2.2 Consented Scheme Comparison

EPR Architects
30 Millbank
London
SW1P 4DU

Proposed Scheme - North-West Elevation

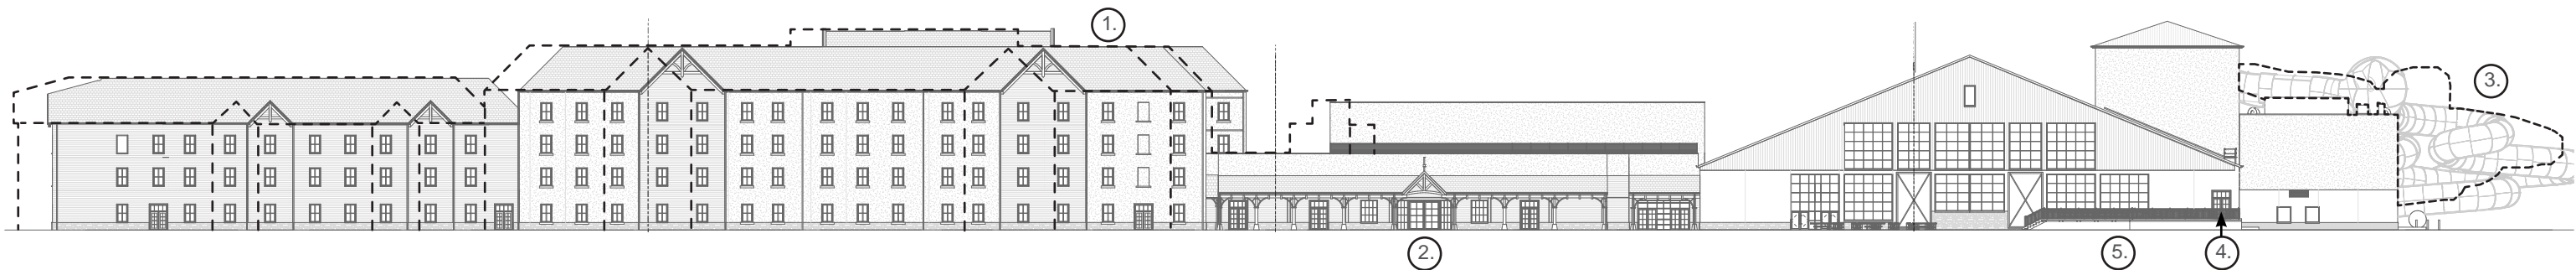
- ① Reduction in the overall size of the FEC resulting in a shift of the guestroom u-shaped tower southwards by approx. 3.6m.
- ② Re-configuration of the conference centre massing, facade design and internal layout.
- ③ Water slide design updated. The overall height of the waterslide remains below the height of the turret which remains fixed.
- ④ Additional door added to create a link from the water park to outdoor terrace.
- ⑤ External water park deck layouts revised and height levels updated to facilitate raised terrace zone with associated balustrade. Enlargened square to the South East corner created to host new outdoor whirlpool design.

Proposed Scheme - North-West Elevation

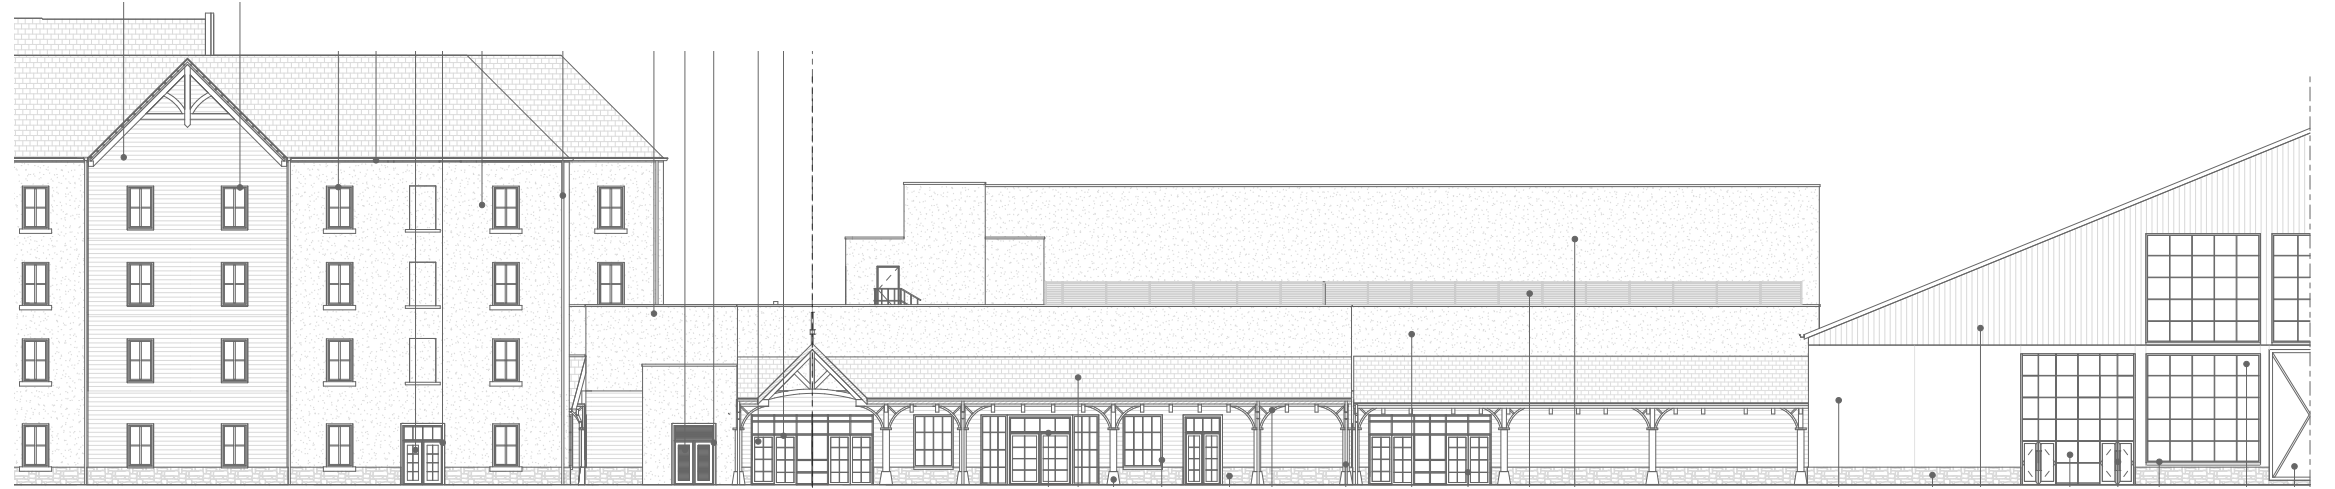
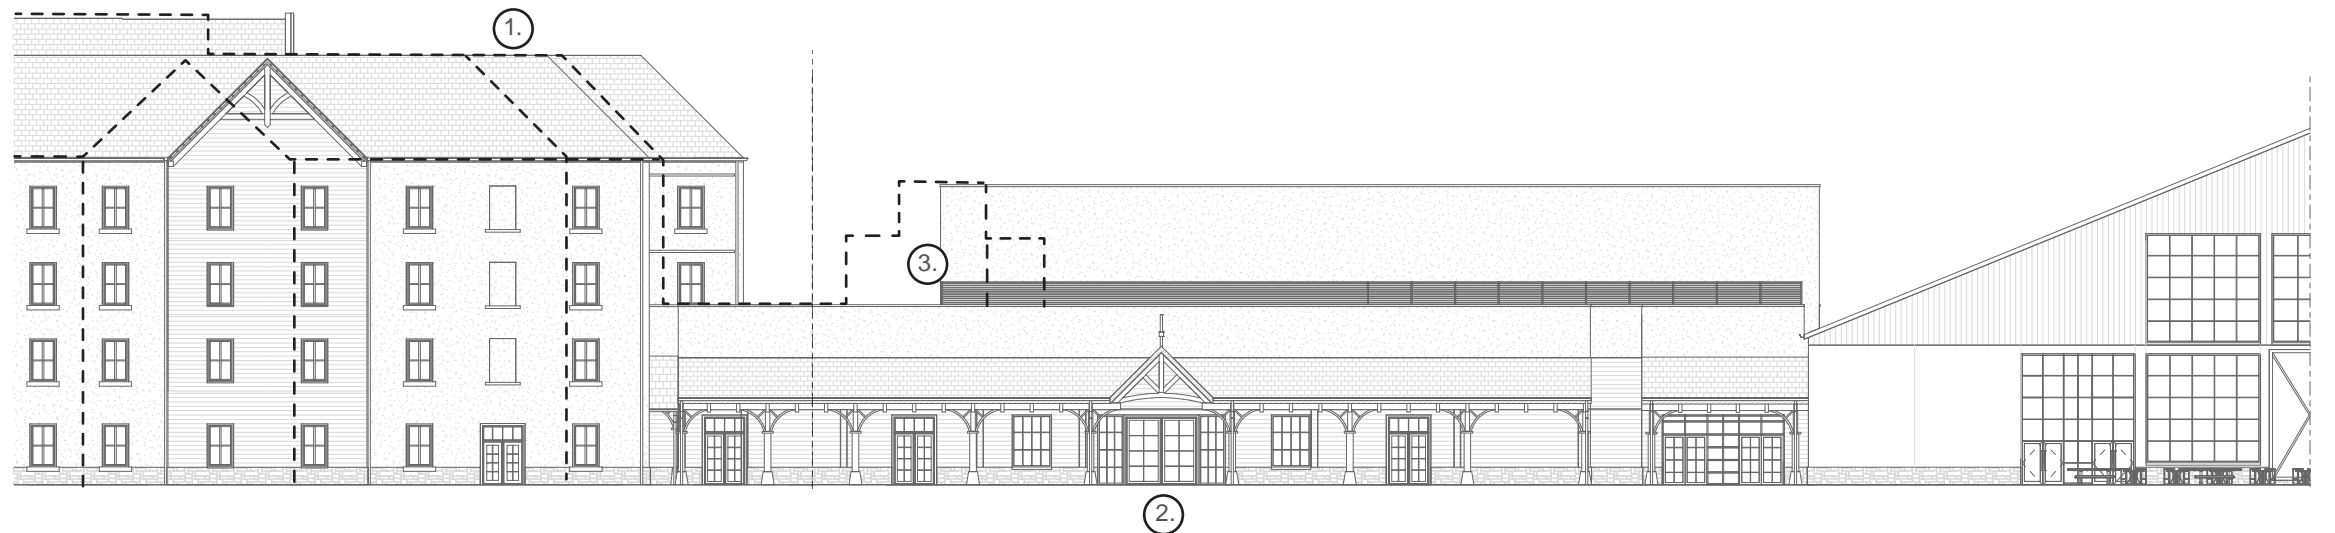
- ① Reduction in the overall size of the FEC resulting in a shift of the guestroom u-shaped tower southwards by approx. 3.6m.
- ② Re-configuration of the conference centre massing, facade design and internal layout.
- ③ Omission of bridge link above FEC roof for access and maintenance.

Proposed Scheme - South-West Elevation

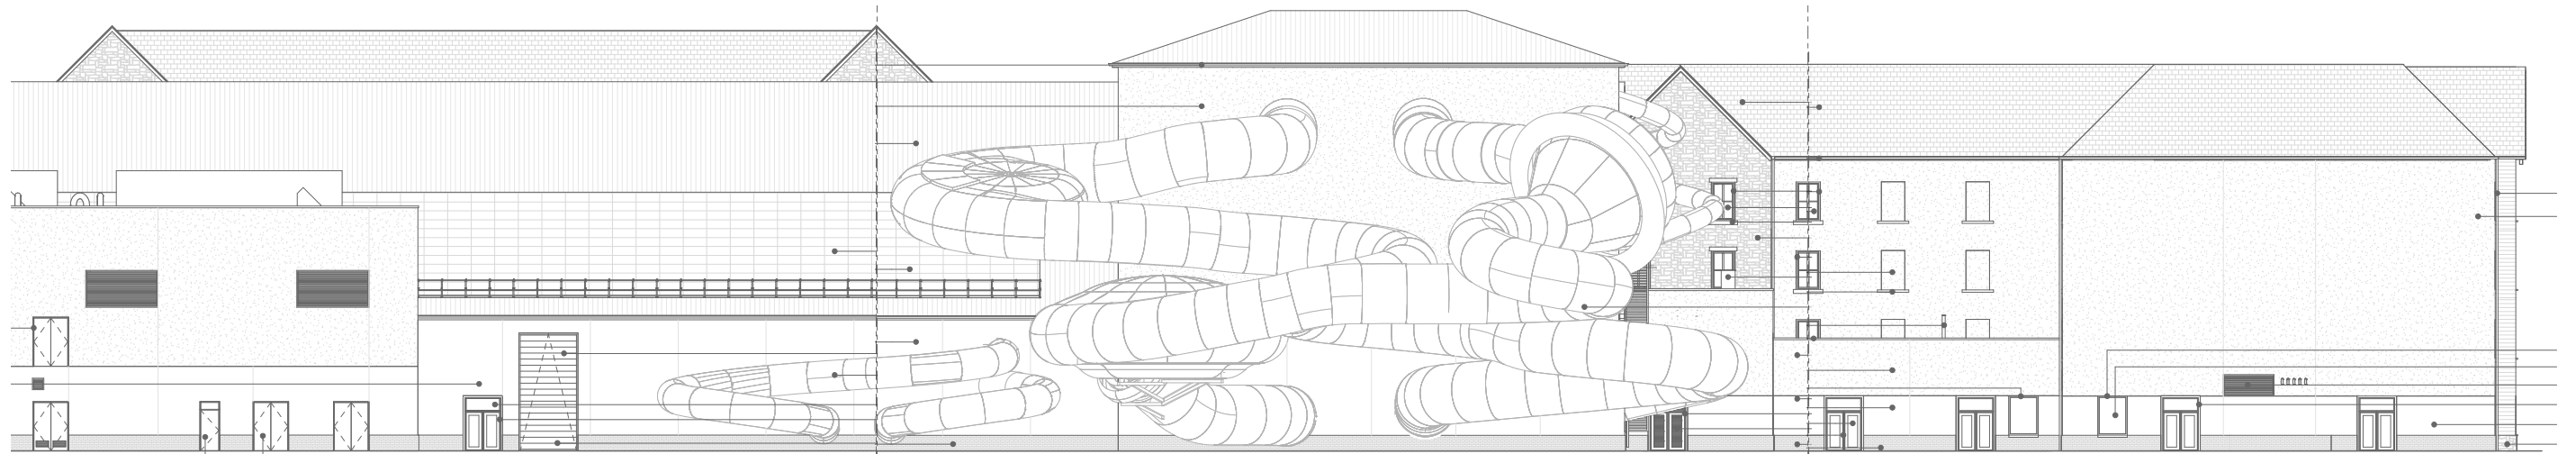
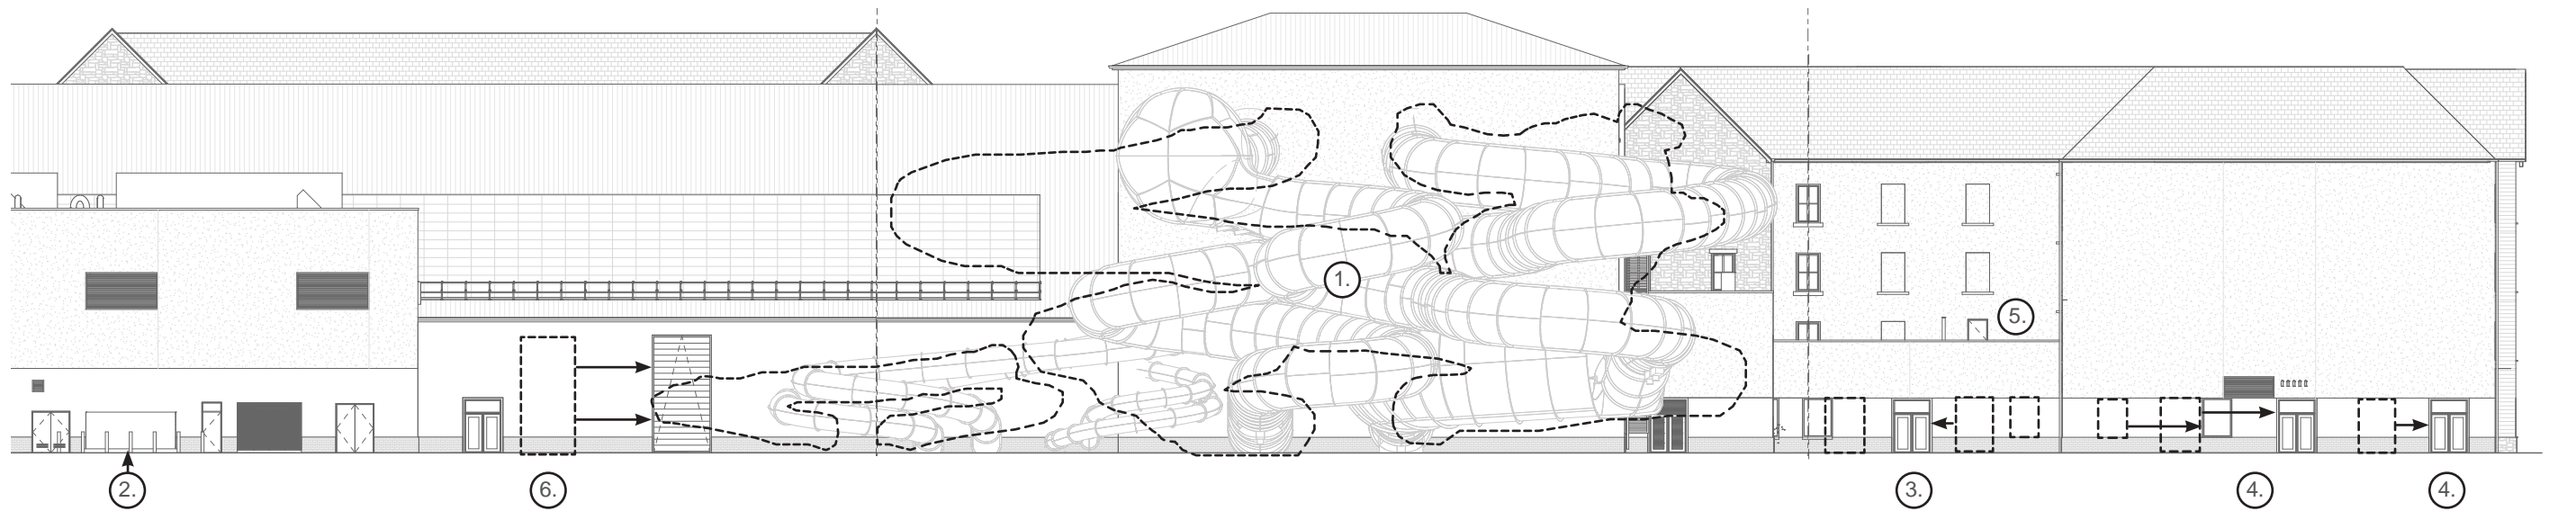
- ① Water slide design updated. The overall height of the waterslide remains below the height of the turret which remains fixed.
- ② External exposed Co2 storage tank to be located outside the proposed bunker building. Storage tank to be sat on a 3.6mx4.5m concrete plinth with perimeter bollards.
- ③ 1 no. double doorset and window removed from this elevation. Remaining double doorset relocated due to internal reconfiguration.
- ④ Window and double door setting out on rear elevation updated due to internal reconfiguration.
- ⑤ External door added for staff only roof access from first floor level.
- ⑥ External roller shutter relocated on facade.

Proposed Scheme - South-East Elevation

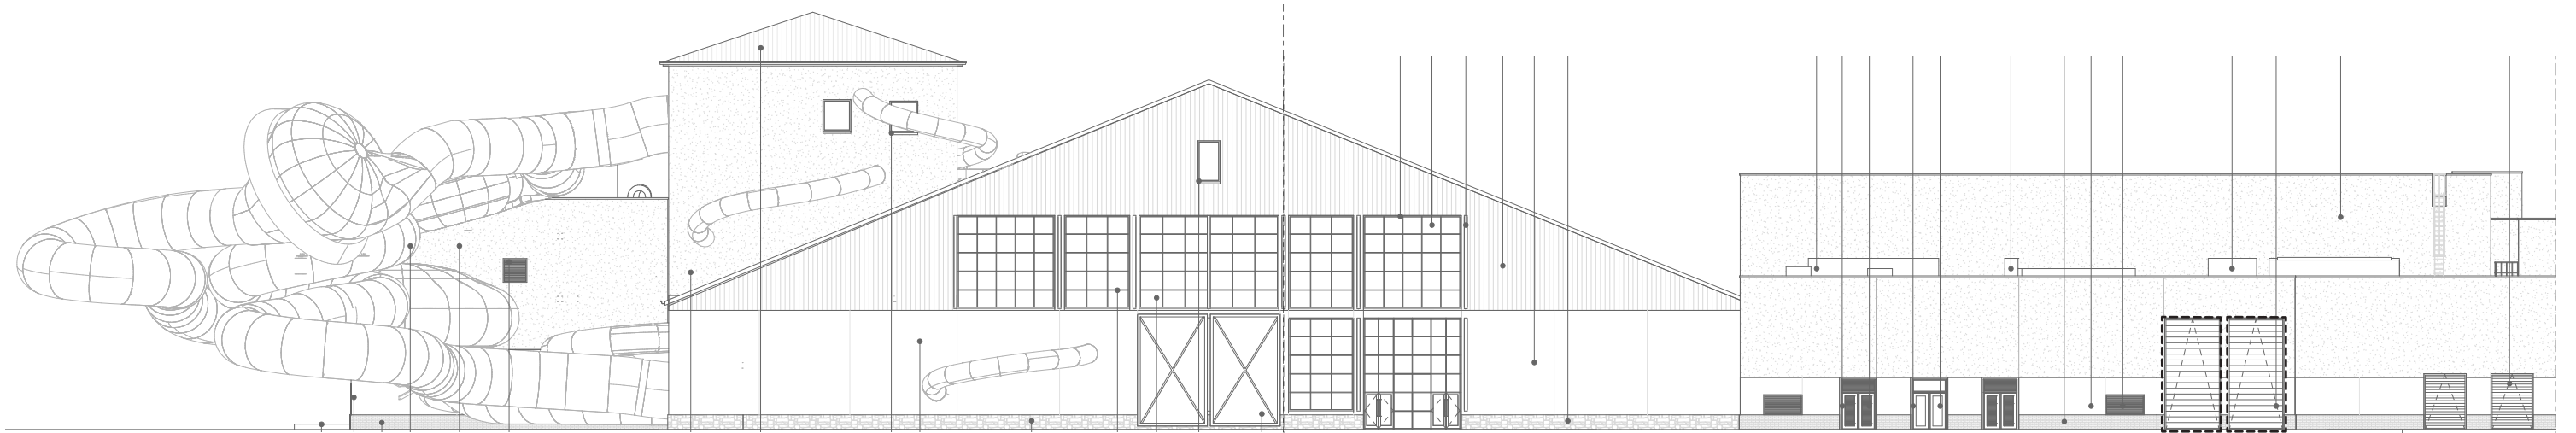
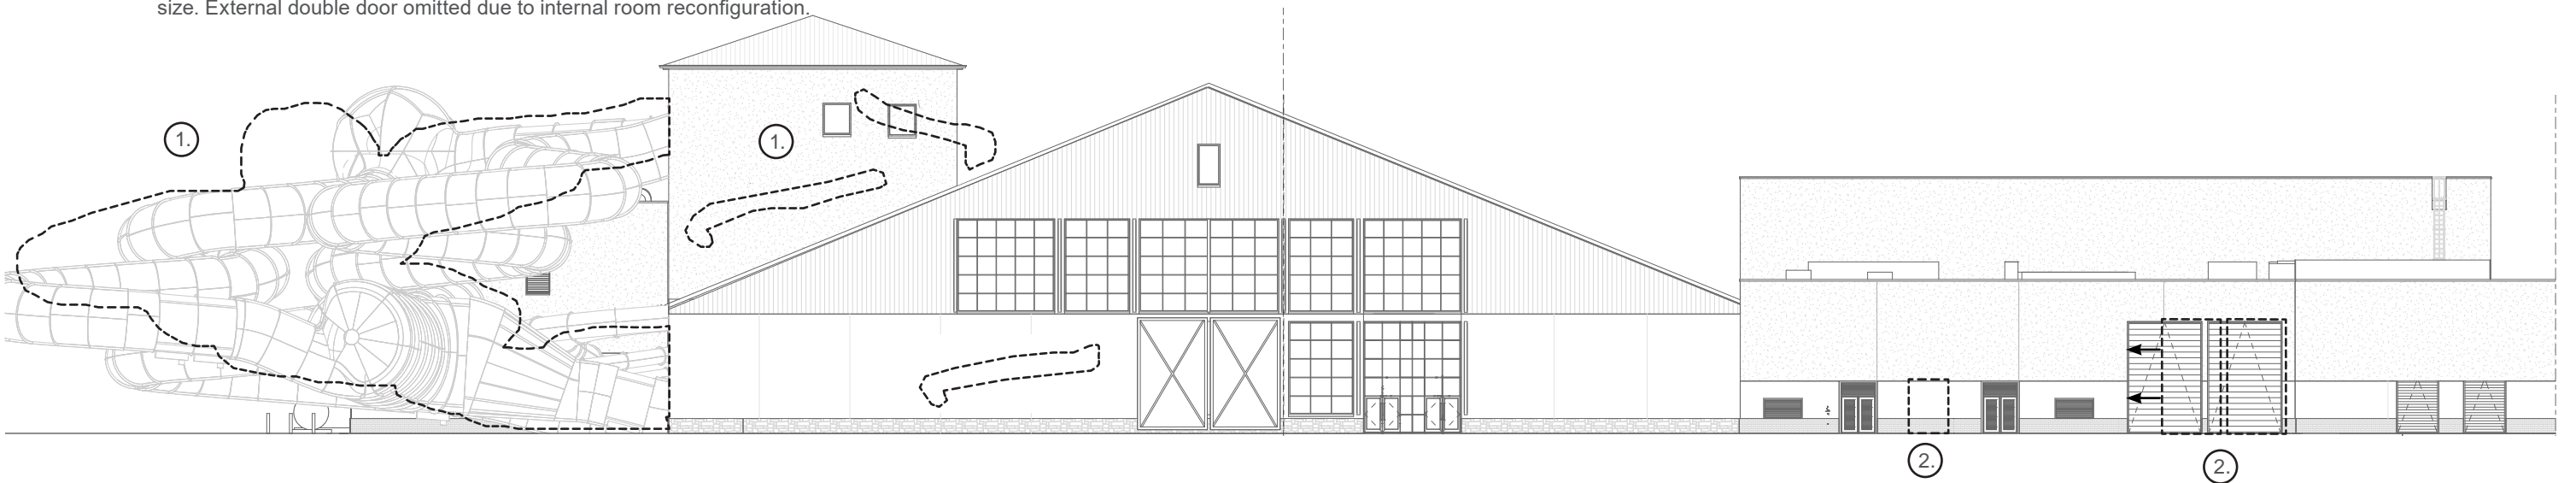
- ① Water slide design updated. The overall height of the waterslide remains below the height of the turret which remains fixed.
- ② Waste compactor rolling shutter and external grille locations updated to suit new compactor room size. External double door omitted due to internal room reconfiguration.
